Seeburg  
Service **Select-o-matic** Bulletin

"TRIP-OFF" ADJUSTMENT

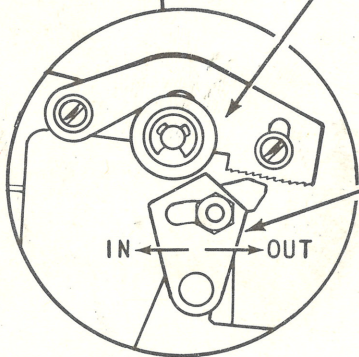
If the hole in a record is "off-center" it can cause the pickup to move in and out and trip before the record has finished playing. If you have records like this - -

loosen these screws and move the "saw" up a little. The higher it is, the less effective - - all the way up, it is not in use and - -

all trip action will work from the "shoe". Move shoe in for early trip - - out for later trip.
